UN#07-015

Subject: UniStar Nuclear, NRC Project No. 746
Response to NRC August 23 Letter Regarding Status of
Acceptance Review of Part 1 of the Combined License Application

**Response to NRC August 23, 2007 Letter Regarding Status of Acceptance
Review of Part 1 of the Combined License Application**

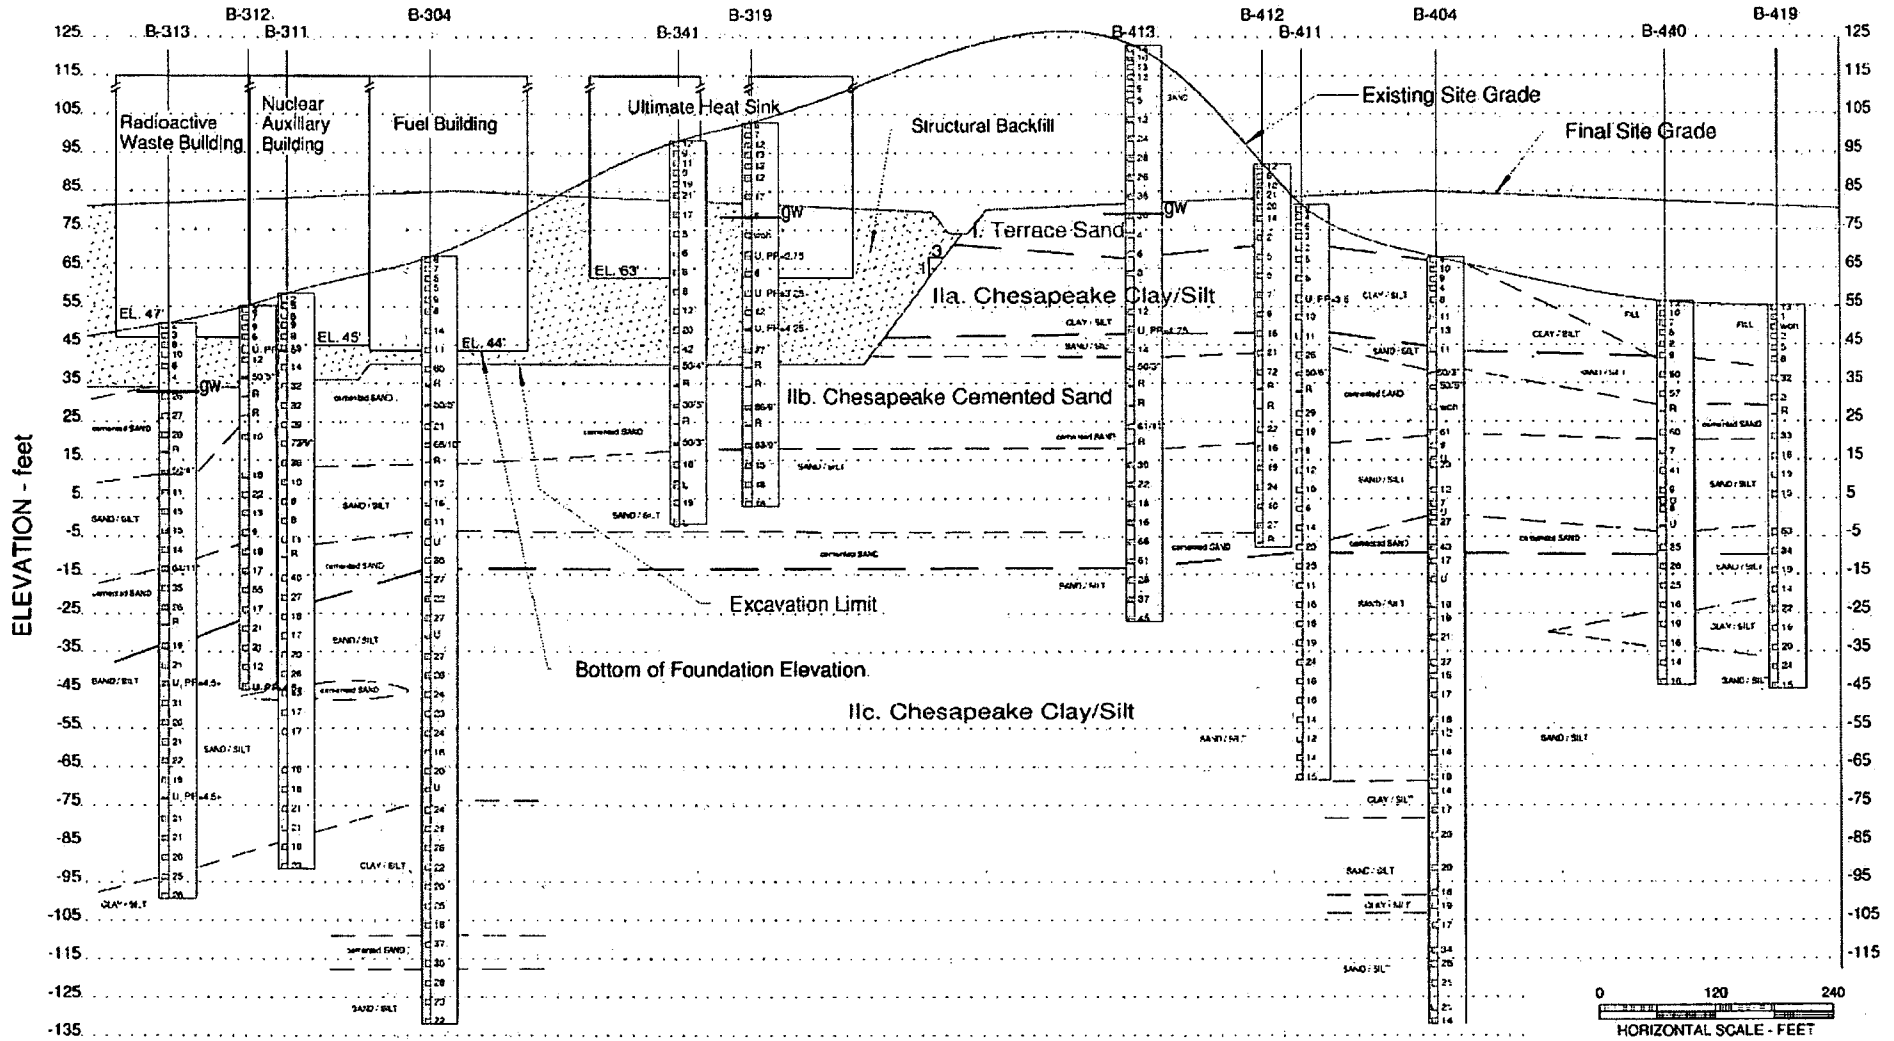
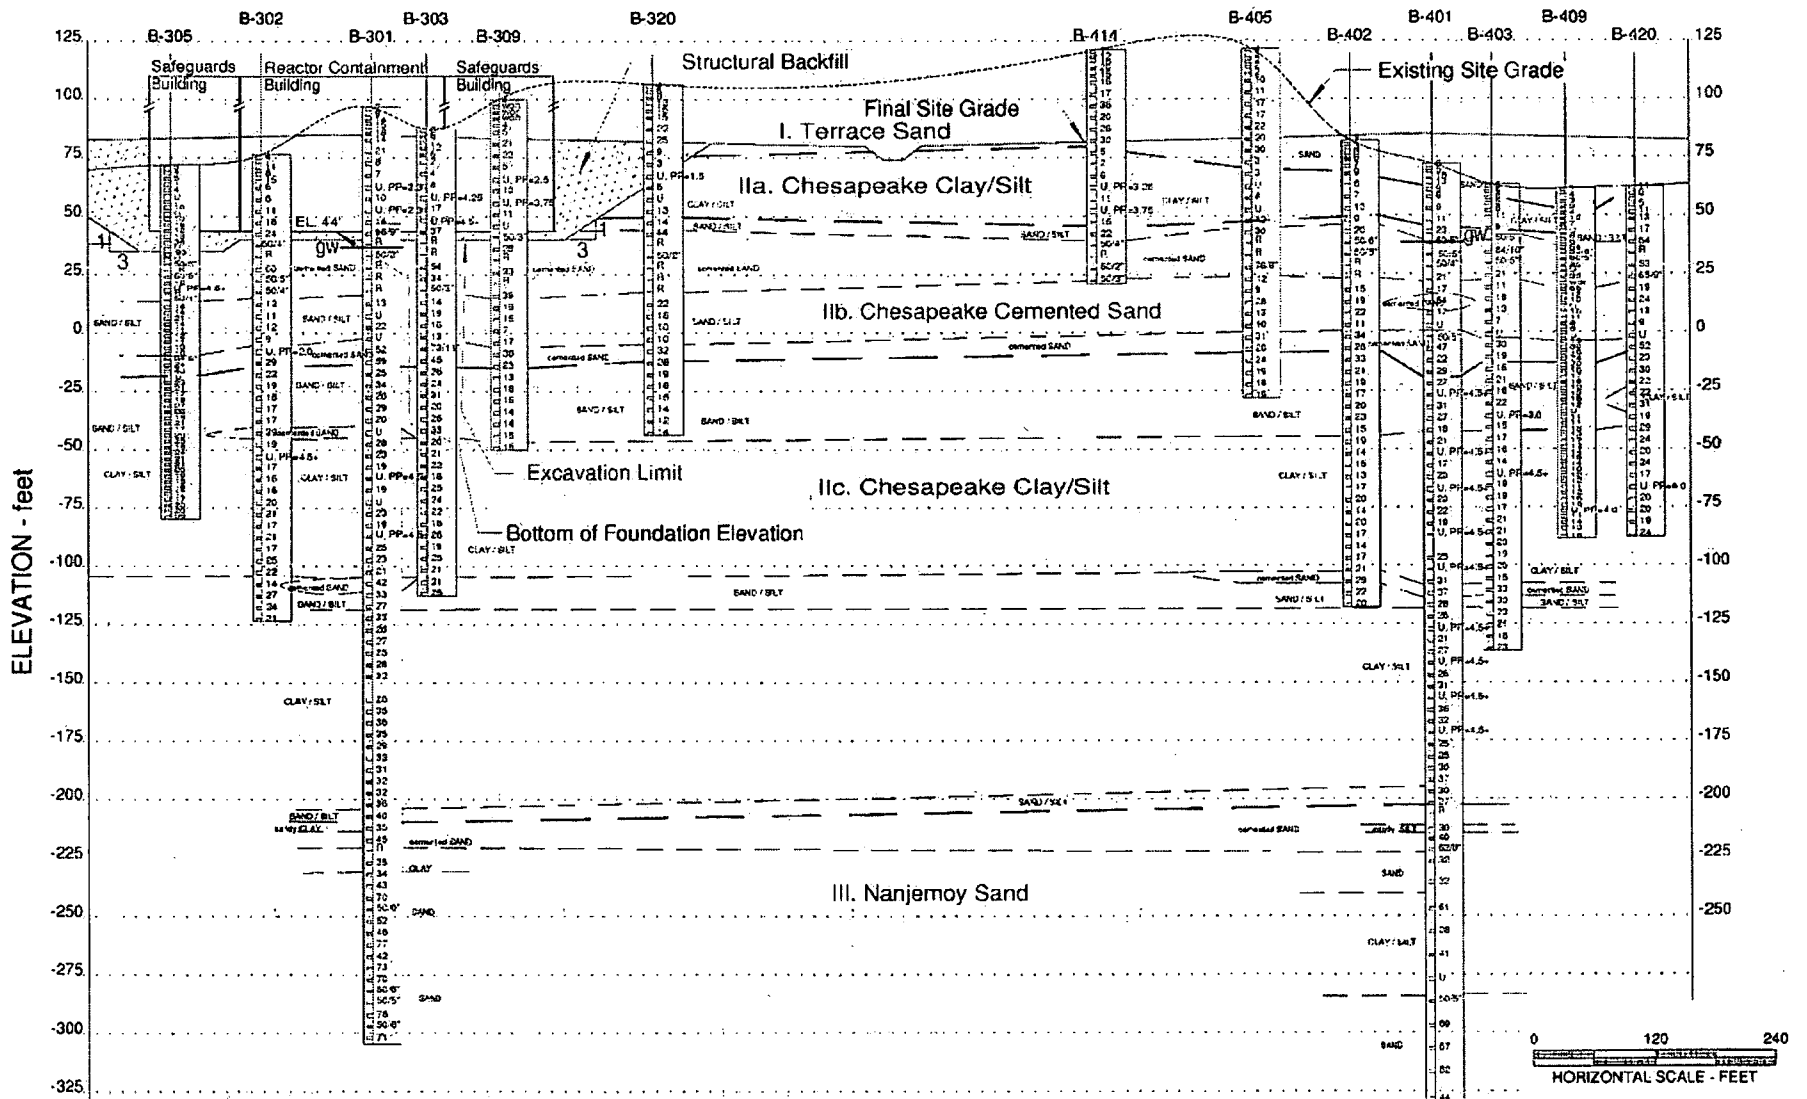
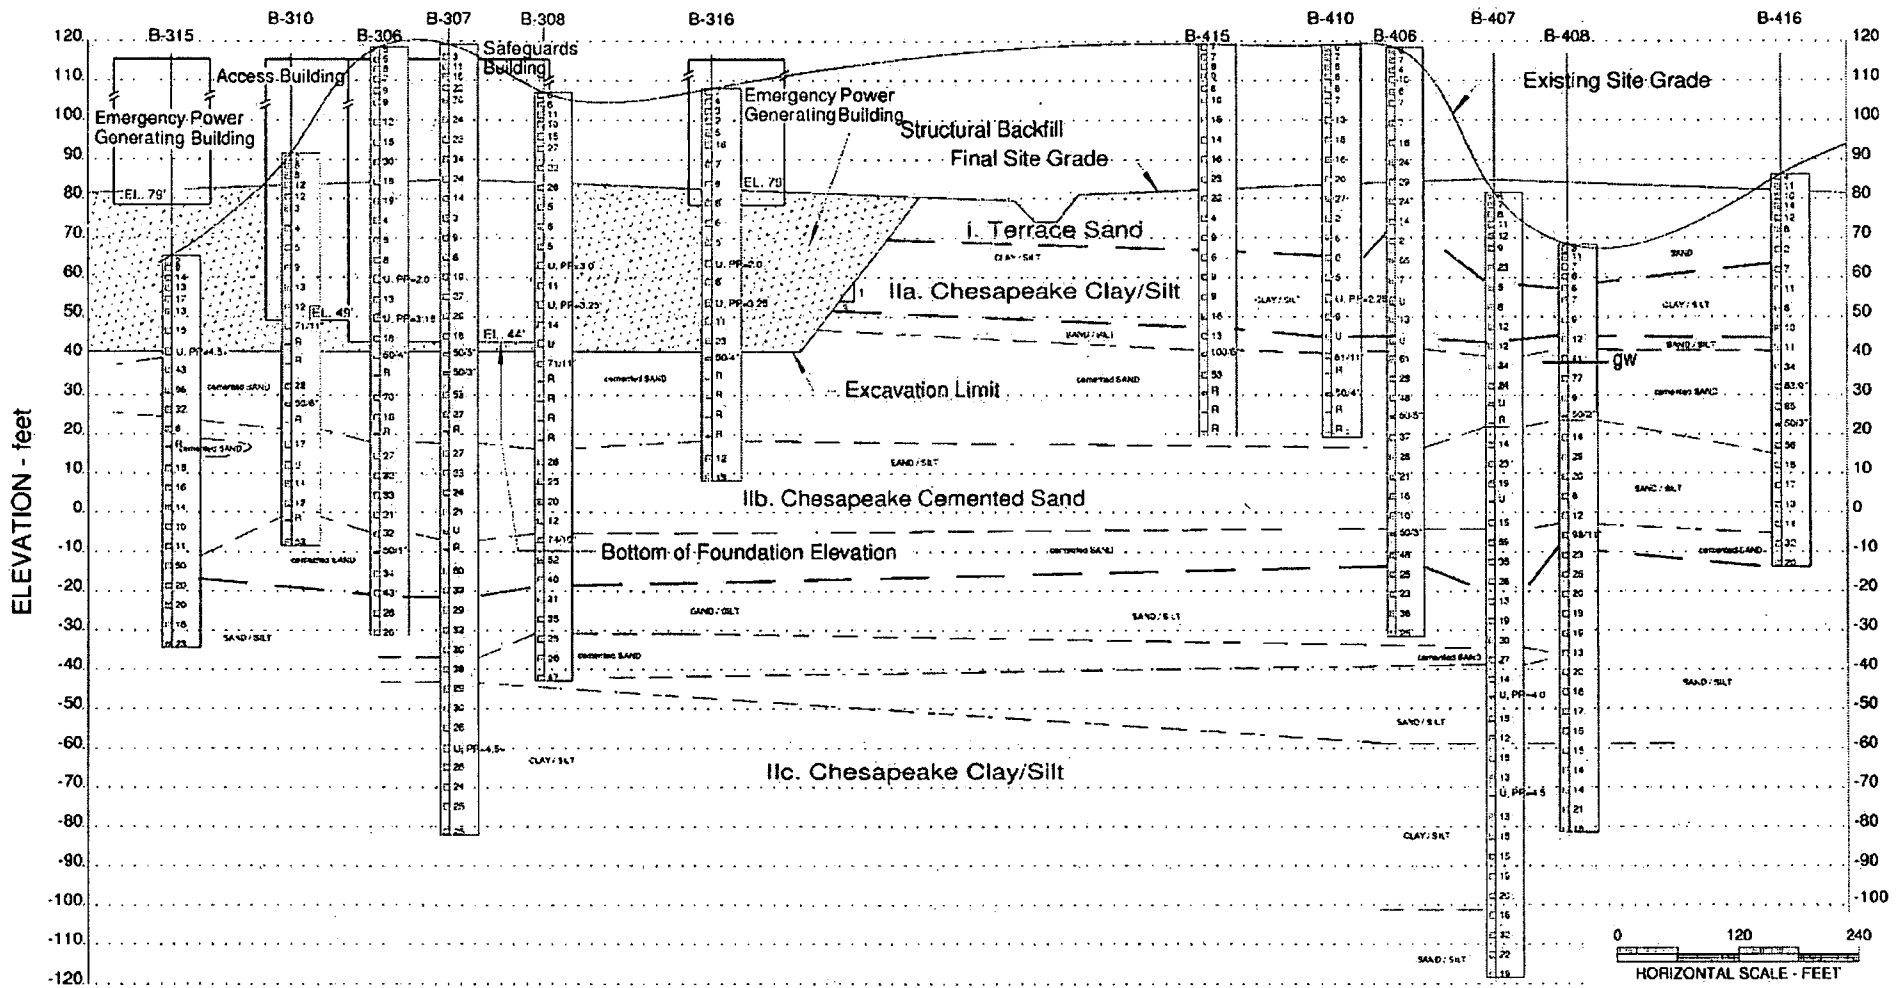
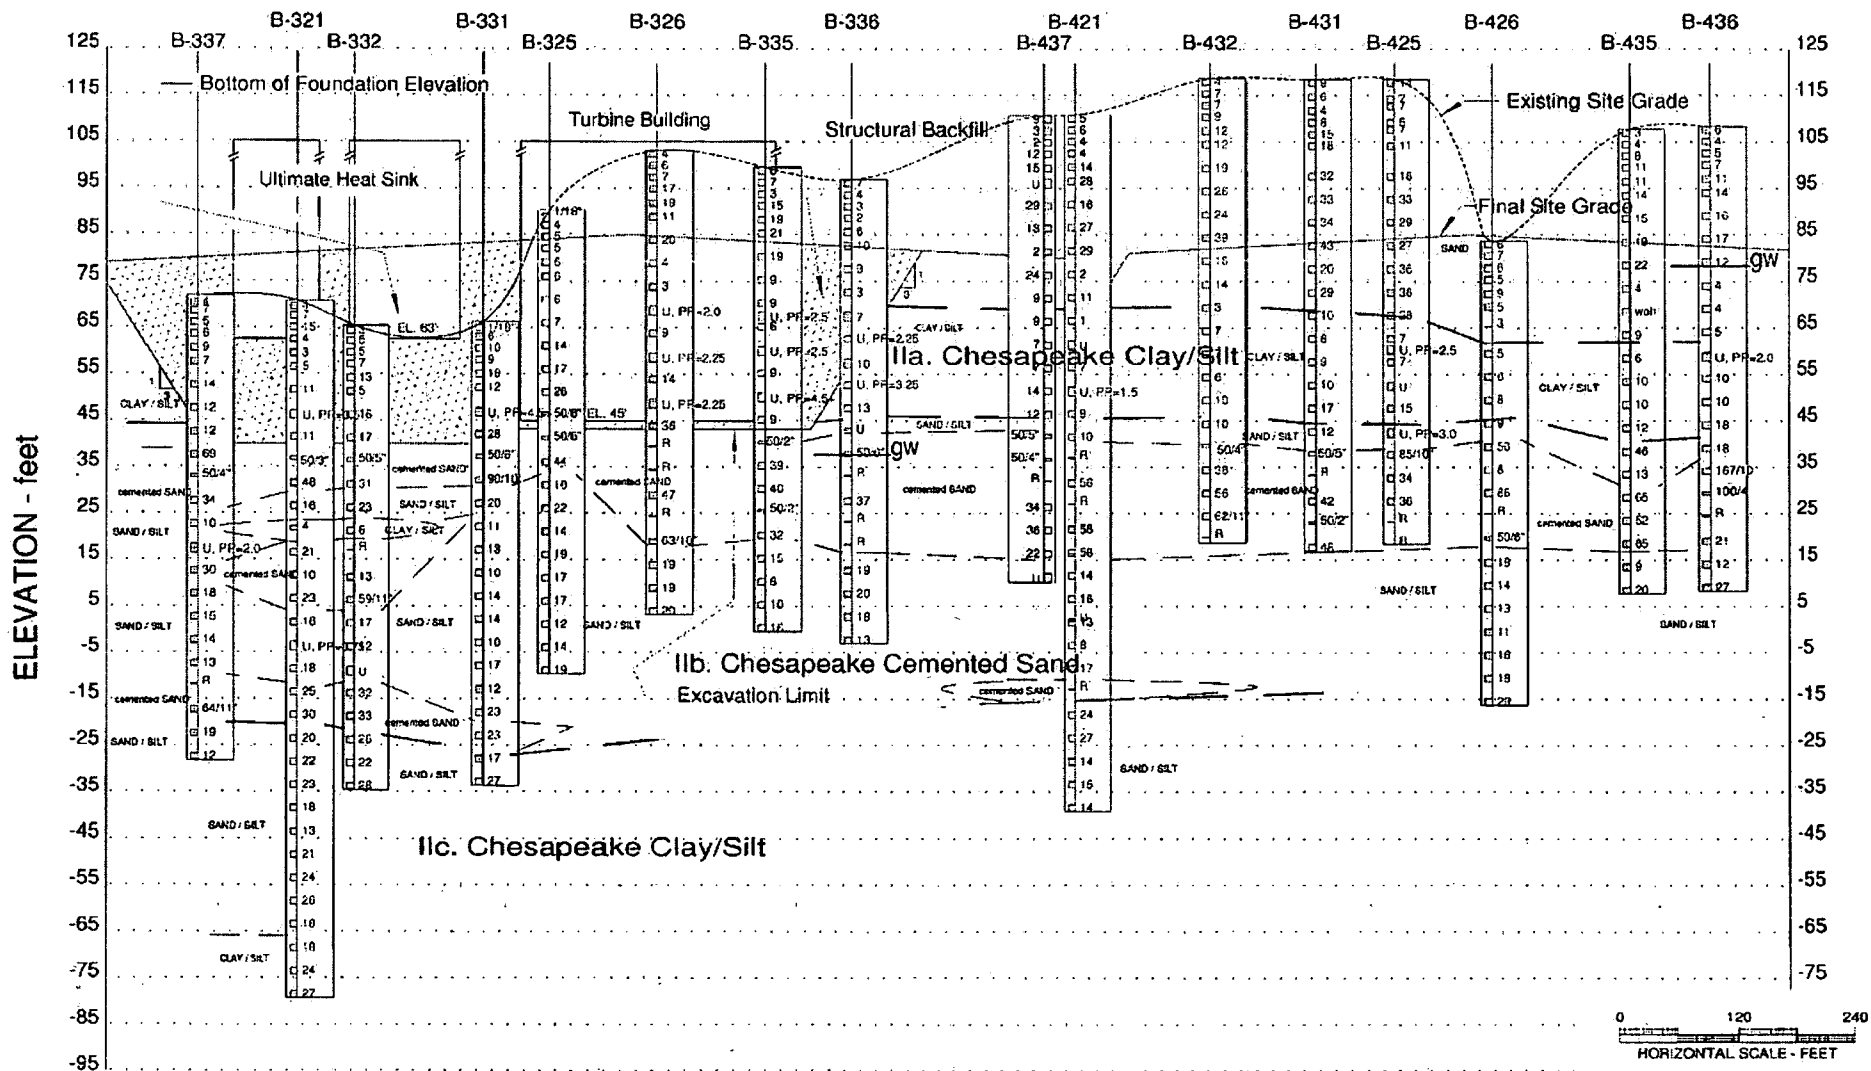
To assist in determining how information submitted in this area may or may not address the requirements of 10 CFR 50.34(a)(1), the staff uses RG 1.206, "Combined License Applications for Nuclear Power Plants." RG Section C.1.2.5.4.5 guidance indicates that a COL applicant should "... discuss the following data concerning excavation, backfill and earthwork analysis at the site: (1) Sources and quantities of backfill and borrow; (2) Extent (horizontally and vertically) of all seismic Category I excavations, fills, and slopes; (3) Compaction specifications and embankment and foundation designs; (4) Dewatering and excavation methods and control of ground water during excavation to preclude degradation of foundation materials." The applicant has not submitted this information nor did it propose an acceptable alternative. Therefore, the staff cannot evaluate how this information may or may not meet the requirements of 10 CFR 50.34(a)(1).

Permanent excavation and fill slopes, created due to site grading, are addressed in Section 2.5.5. Temporary excavation slopes, such as those for foundation excavation, are graded on an inclination not steeper than 2:1 horizontal:vertical (H:V) or even extended to inclination 3:1 H:V, if found necessary, and having a factor of safety for stability of at least 1.30 for static conditions. These slopes are currently shown as 3:1 H:V in Figures 2.5.4-28 through 2.5.4-31.

{Major structures derive support from the very dense cemented soils or compacted structural backfill. Given the planned foundation depths and soil conditions at these depths, as shown in Figures 2.5.4-28 through 2.5.4-32, no special ground improvement measures are warranted. Ground improvement is limited to excavation of unsuitable soils, such as existing fill or loose/soft soils, and their replacement with structural backfill. It also includes proof-rolling of foundation subgrade for the purpose of identifying any unsuitable soils for further excavation and replacement, which further densifies the upper portions of the subgrade. In absence of subsurface conditions at the site that require ground improvement, ground control, i.e., maintaining the integrity of existing dense or stiff foundation soils, is the primary focus of earthworks during foundation preparation. These measures include groundwater control, use of appropriate measures and equipment for excavation and compaction, subgrade protection, and other similar measures.}
